ATTACHMENT A: Project Modification Request (PMR) FORM

Regional Program	<input checked="" type="checkbox"/> Infrastructure Program Project <input type="checkbox"/> Scientific Studies Program <input type="checkbox"/> Technical Resources Program
Project/Study Name	Fairplex Stormwater Capture Project
Project/Study Lead	City of Pomona, Water Resources Department
Watershed Area(s)	Upper San Gabriel River
Current Project Phase	Design
Approved Stormwater Investment Plan Fiscal Year	FY2021-22
Transfer Agreement ID (e.g., 2020RPULAR52)	2021RPUSGR03

Project Modification Request Form, Supplemental Information

SUBJECT: Fairplex Stormwater Capture Project
Concept Evaluation Memorandum

Figure 1-1. Original Fairplex Concept Design (*Safe, Clean Water Program Feasibility Study Report, 2021*)

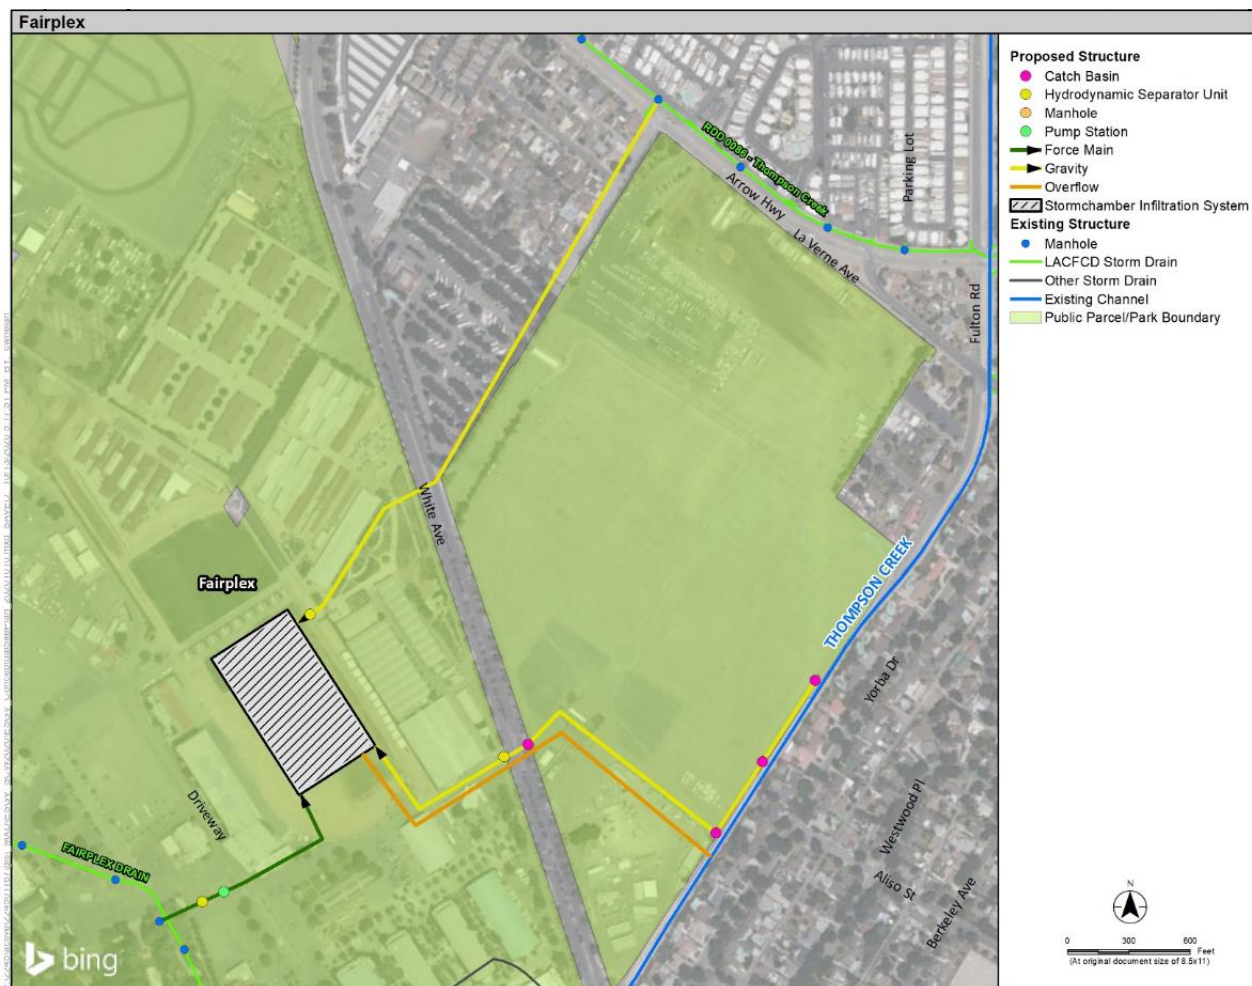
The original design as approved and funded by SCW Program (see **Figure 1-1**) proposed a 28 ac-ft subsurface storage structure that takes diverted stormwater from three diversion lines: 1) the north line diverts flows from LACFCD's RDD0086 – Thompson Creek Drain along W Arrow Hwy through gravity, 2) the east line diverts surface runoff from catch basins through gravity, and 3) the west line pumps flows from LACFCD's Fairplex Drain (North of W McKinley Ave). The overflow line connects the storage to Thompson Creek.

1.2 Reasons to Update the Original Design

The original concept design used a design infiltration rate of 0.44 in/hr measured at a well approximately 4300 ft from the proposed infiltration gallery. This infiltration test performed in December 2020 was likely following [*GS200.2 Guidelines for Geotechnical Investigation and Reporting Low Impact Development Stormwater Infiltration \(2017\)*](#) which is replaced by [*GS200.1 Guidelines For Geotechnical Investigation and Reporting Low Impact Development Stormwater Infiltration \(2021\)*](#). The two versions calculate the total reduction factor differently which will cause the design infiltration rate to differ:

The concept evaluation performed in this memo will not use this infiltration rate because of the large distance between the test well and site and the outdated infiltration test standard. Filtration is considered the main discharge method at the concept evaluation stage. Once a project site is selected and site-specific geotechnical investigation is completed, infiltration discharge at that project site can be evaluated.

Figure 1-2. Original Fairplex Drainage Area (with Inset showing full stormdrain network)

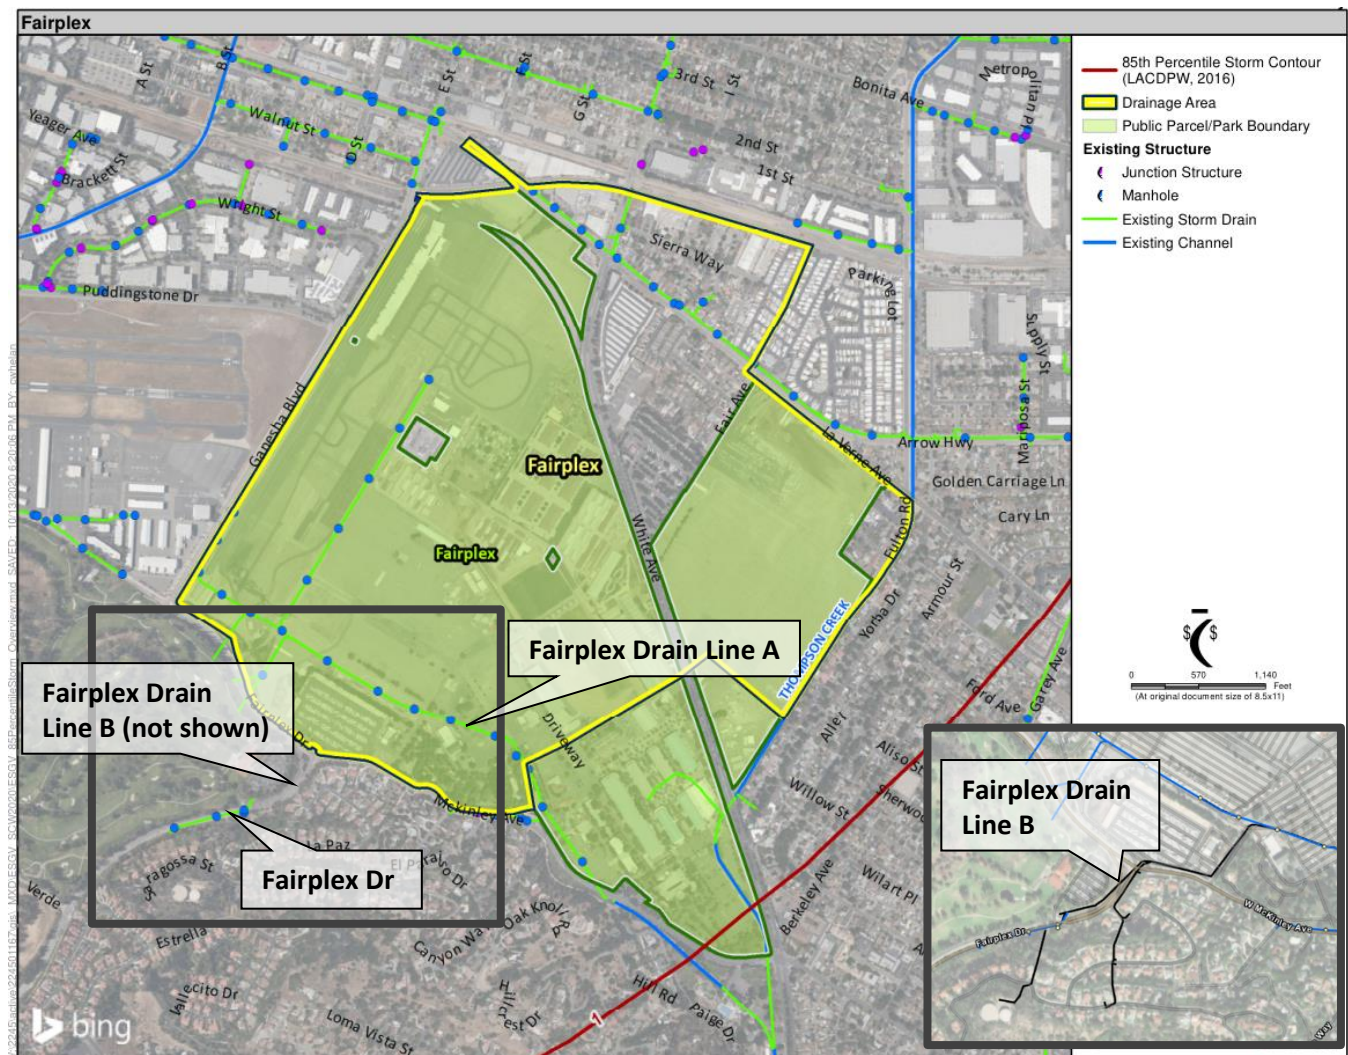
The original drainage area delineation did not account for LACFCD Fairplex Drain Line B along Fairplex Dr (see black storm drains in **Figure 1-2**). This line conveys flows generated by Mountain Meadows Golf Course and the residential area next to Fairplex Dr. Line B eventually joins Line A which is the drain the project diverts from. The original project drainage area needs to be extended to reflect this new information.

Figure 4-3. Option 3 Concept Plan – Utility

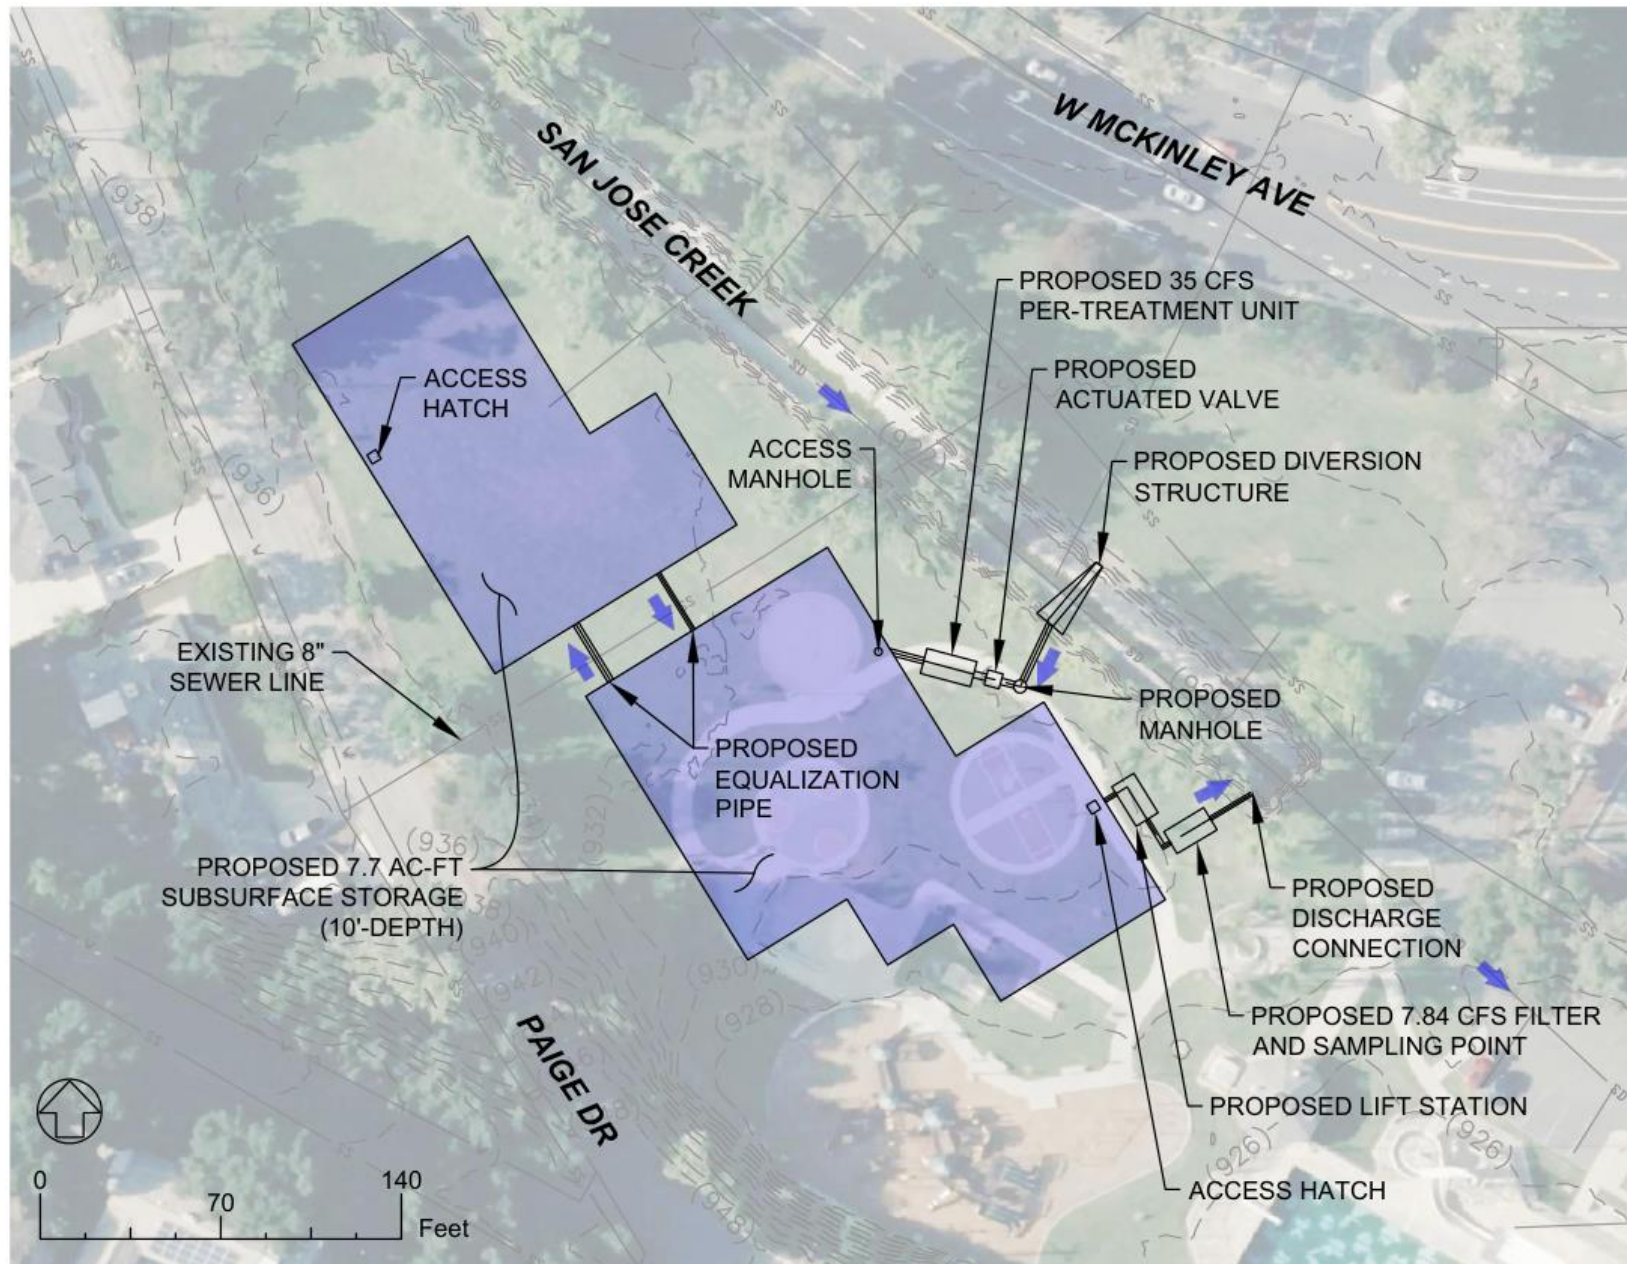
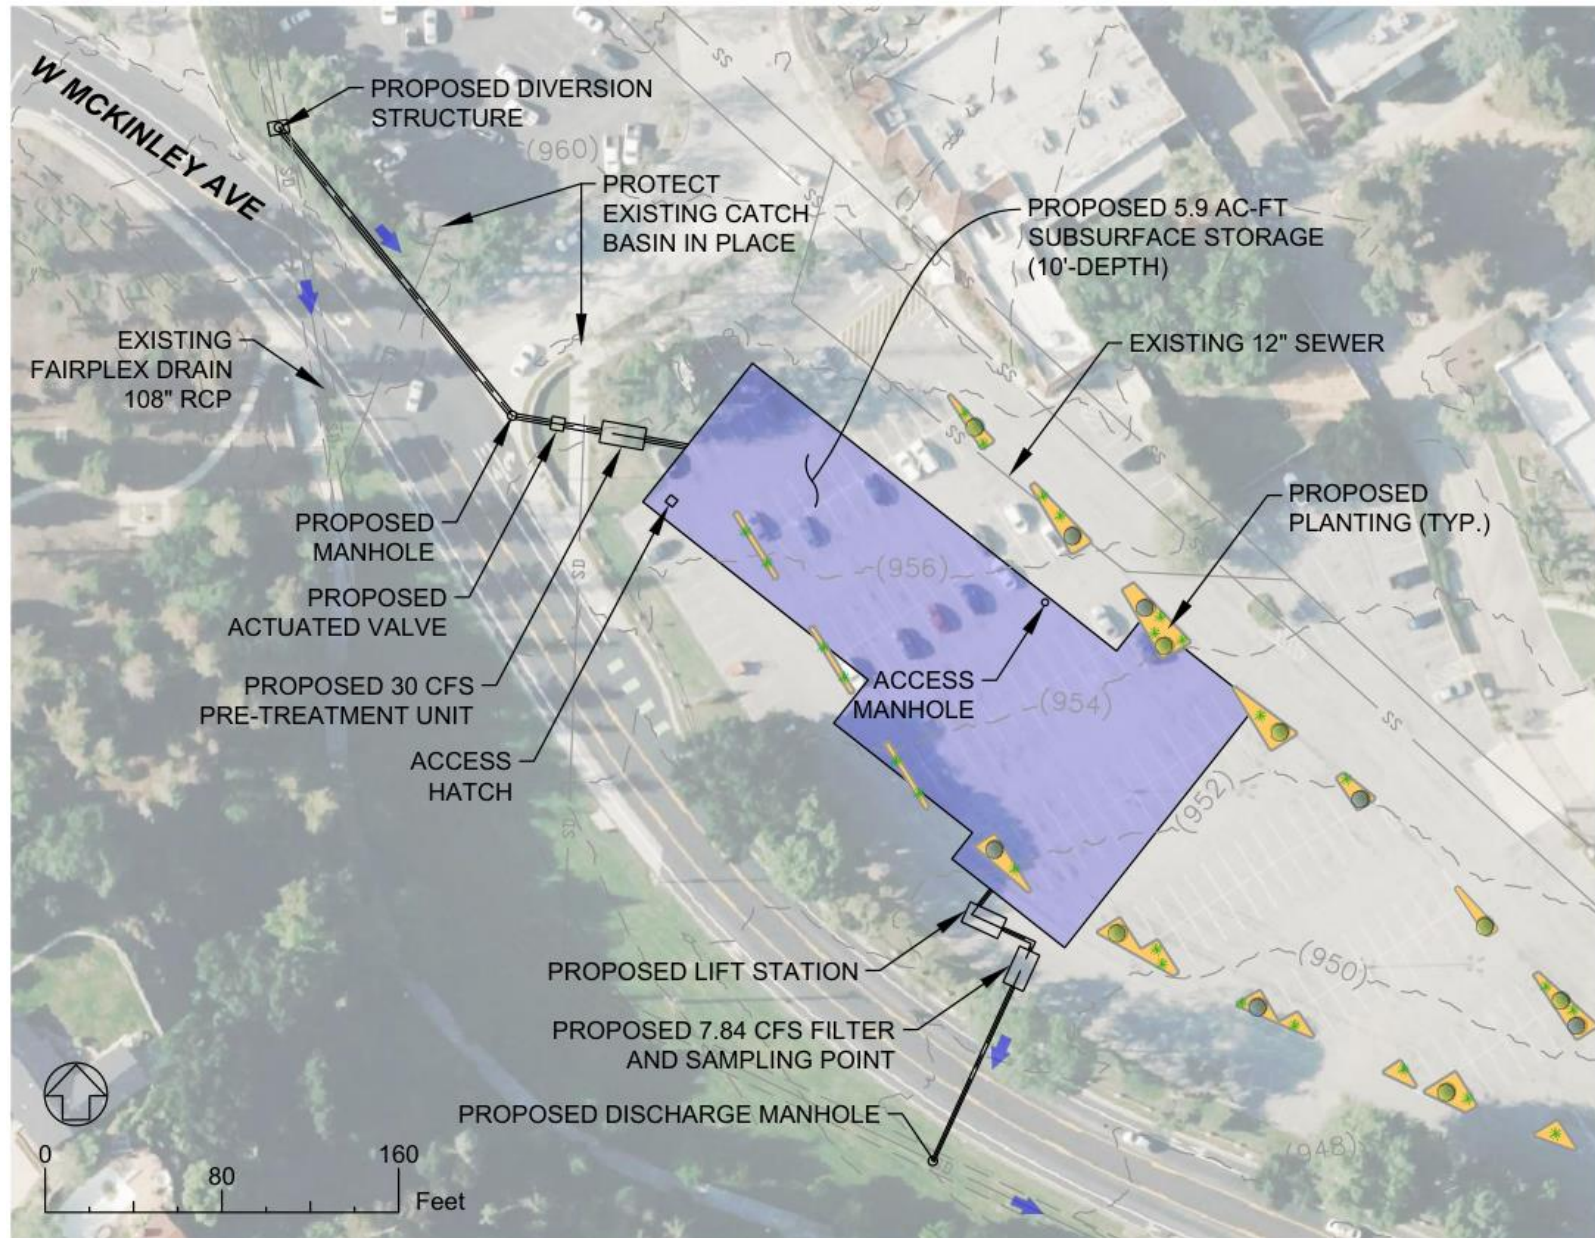
- Project Location – **RELOCATED TO NEARBY PARCEL DIVERTING FROM SAME DRAIN**. The uncertainty added by the development of the Fairplex Specific Plan prompted the City of Pomona to explore alternative project sites. The project was originally located on the Fairplex campus. Furthermore, the Fairplex Association provided a letter in October 2023 indicating that they could not fully support the project at this time. In accordance with the recommendations of the revised analysis, the project was relocated to nearby Ganesha Park. Relocating the project site to a nearby parcel owned and maintained by the City of Pomona was done intentionally to further ensure support for the project will be secured throughout its useful life. A nearby site was selected to ensure that the overall design intent, including treating runoff from the Fairplex Drain, similar to the original approved concept was maintained to the maximum extent practicable.

Option 3 (Figure 4-3 and Figure 4-4) diverts stormwater from San Jose Creek through a pre-treatment unit into a 7.7 acre-feet subsurface storage system. Two underground storage chambers connected by equalization pipes are proposed in Ganesha Park on either side of an existing sewer line. Three access openings will be provided in the park to provide maintenance access to the storage. Stored stormwater is pumped through a filter and discharged back to San Jose Creek. Surface improvements above the subsurface storage include extended walk path, a U8 soccer field, a basketball court, an exercise area, two pavilions, and a bird and butterfly garden.

After evaluating multiple aspects of the four design options, **Option 3 at Ganesha Park is recommended**. The recommended BMP has a 35 cfs gravity diversion from San Jose Creek, a 7.7 ac-ft subsurface storage unit under Ganesha Park, and a 7.84 cfs filtered discharge back to San Jose Creek. Because Ganesha Park is within the City of Pomona's jurisdictional control, the recommended project will not be impacted by the Fairplex Strategic Plan, and site access during design, construction, and O&M will be easier. The proposed sports facilities and landscape features in Ganesha Park will enhance the recreation opportunities enjoyed by the community.
